## APPENDIX F: ADDITIONAL INFORMATION

**RE: 160628 BYLONG COAL PROJECT FORESTRY NSW SUPPLEMENTARY RTS**

**PROPOSED BYLONG COAL PROJECT – FURTHER EPA COMMENT**

**Project number** G1606G  
**Document title** Bylong Coal Project – Response to Supplementary Submissions on Groundwater  
**Site address** Bylong, NSW  
**File name** G1606.Response\_to\_Submissions\_Final.docx

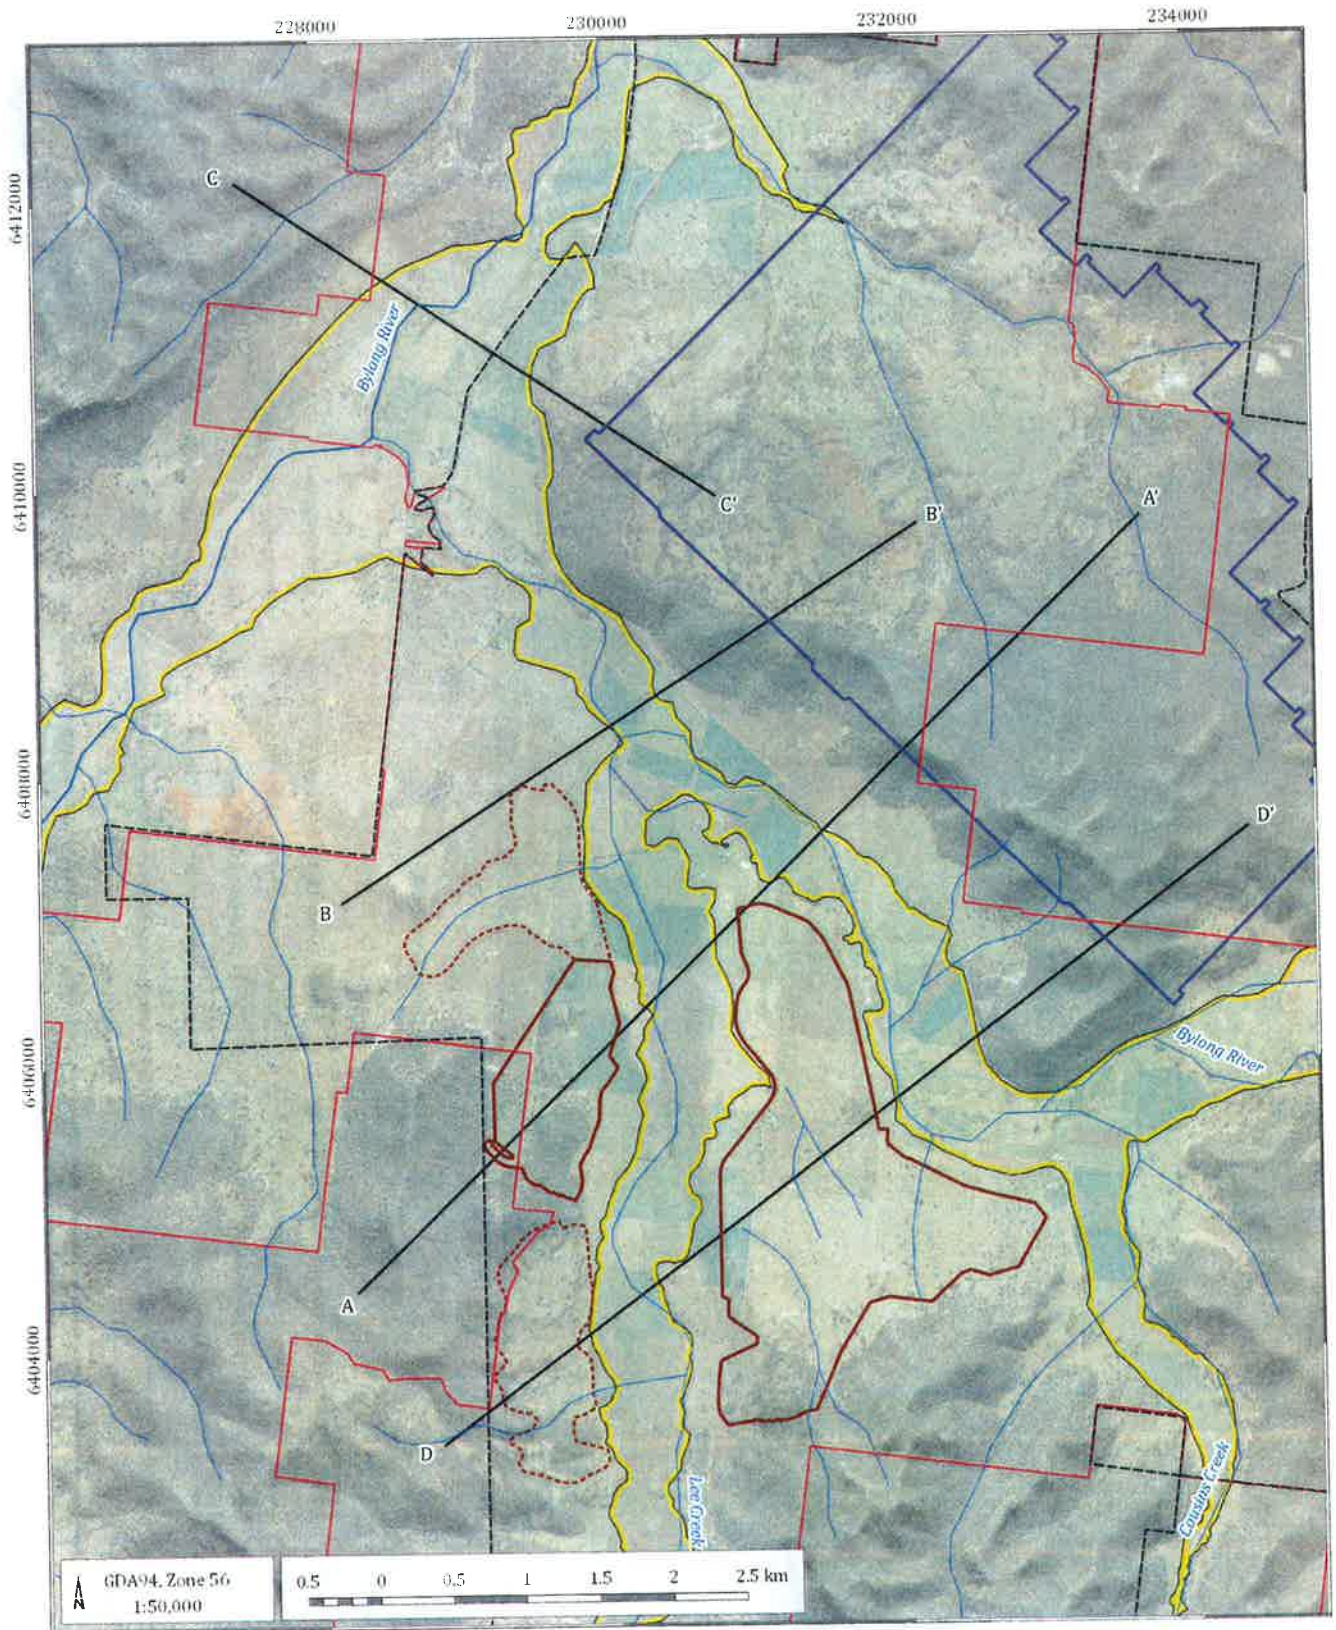
In DPI Water's submission on the RTS it requested additional cross-sections to understand the 3D conceptual geology along the groundwater flow paths from recharge areas towards open-cut or underground mines or beneath coal spoil emplacement areas and towards other water users with detail on the dipping Permian beds.

To address this request the cross sections through the alluvium provided in the RTS were increased both laterally and vertically to incorporate the Permian strata, the catchment area contributing streams and the proposed mining and emplacement areas. A new cross section was also provided through the proposed open cut and underground mining areas further south and upstream.

Figure 3-1 shows the locations of the cross sections, whilst Figure 3-2 to Figure 3-5 shows the geological units along each cross section line. The cross sections are based on the groundwater model and therefore show the stratigraphic unit(s) each model layer represents. Adjacent monitoring bores are projected onto each cross section.

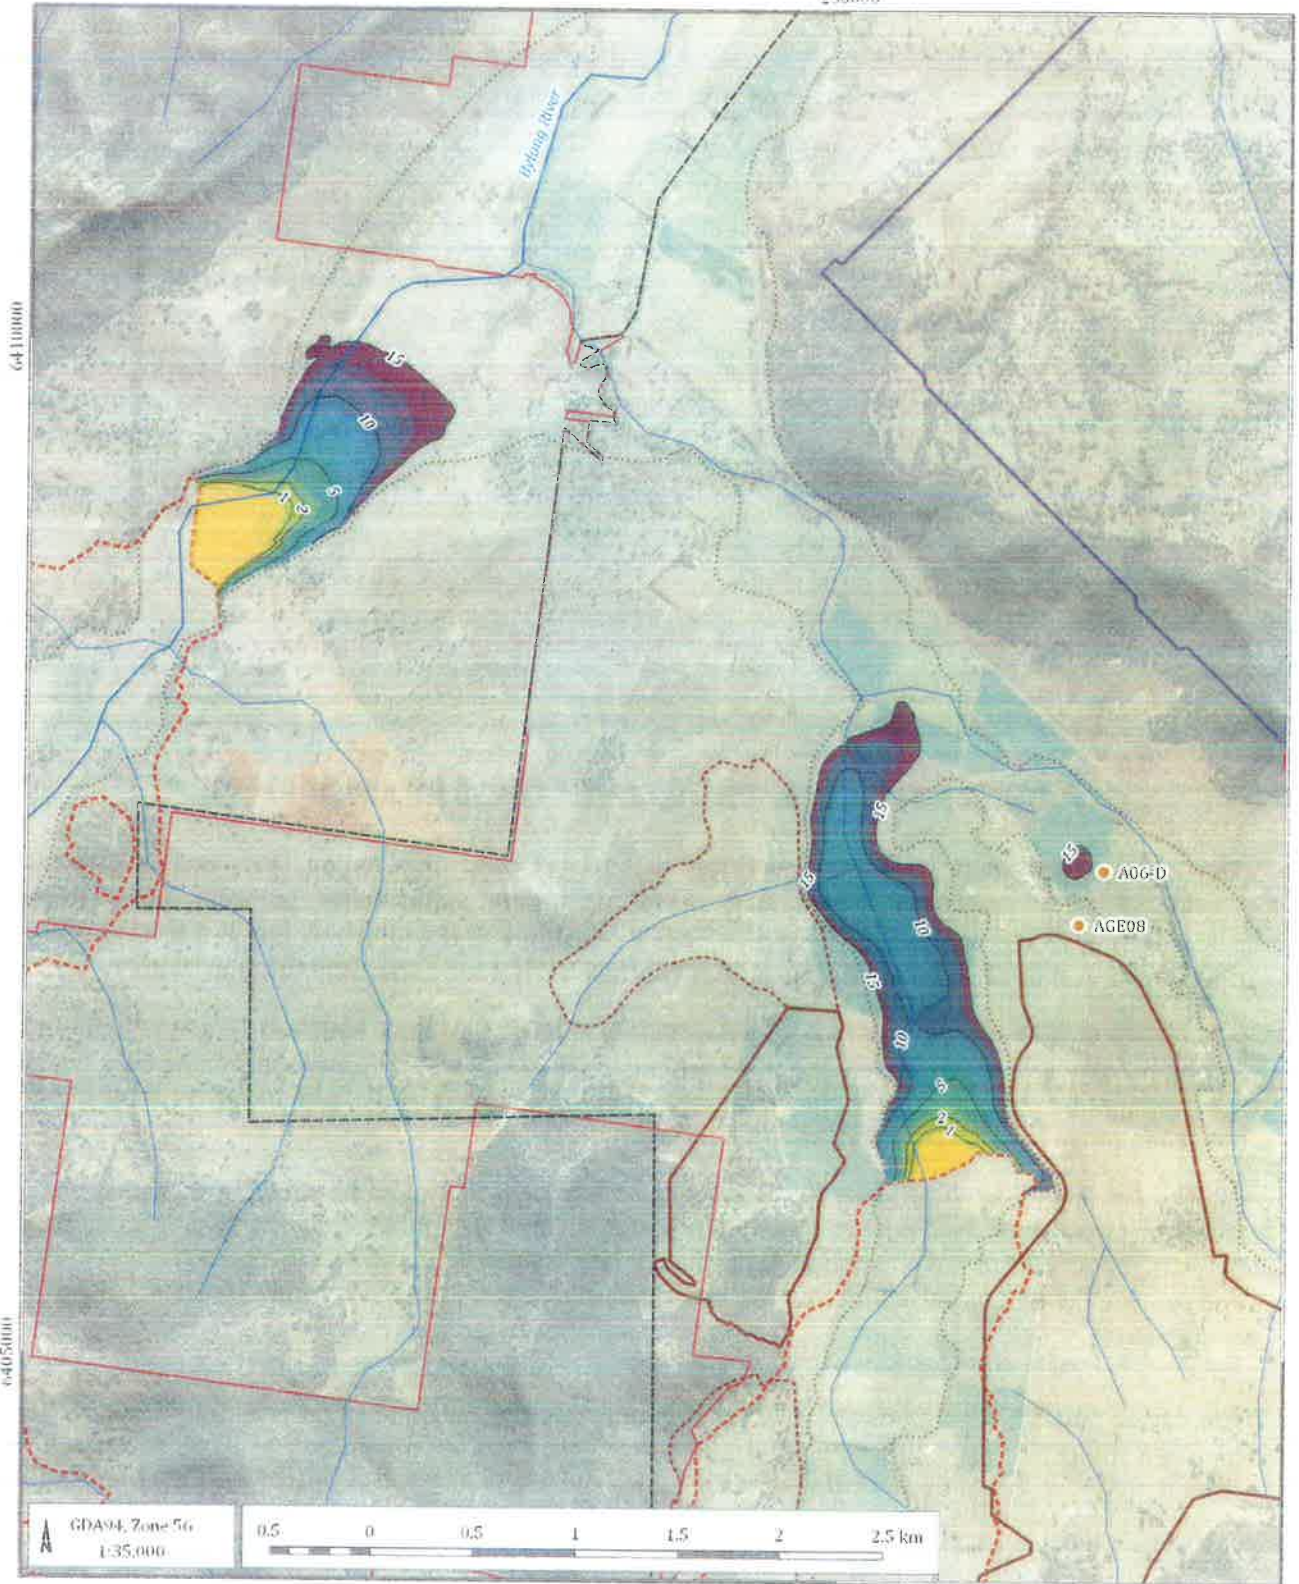
DPI Water interpreted from maps presented within the RTS document that a hydraulic connection between the Quaternary alluvial aquifer and the Coggan Coal seam aquifer was likely to exist. It is agreed that the available data does indicate in some areas there is a direct or direct hydraulic connection between the alluvium and the coal seams proposed to be mined. Figure 5-19 shows where the Coggan Coal seam either subcrops below the alluvium, or outcrops close to the land surface. The areas where the coal seam subcrops directly beneath the alluvium, or is separated by a thin layer of weathered Permian sediments will be areas where the connectivity is enhanced. Figure 5-19 shows this occurs primarily in the area of the Lee Creek alluvium between the Eastern and Western open cut mining areas. Towards the south of this area the coal seams outcrop above the water table and therefore do not have any direct connection with the alluvial aquifer.
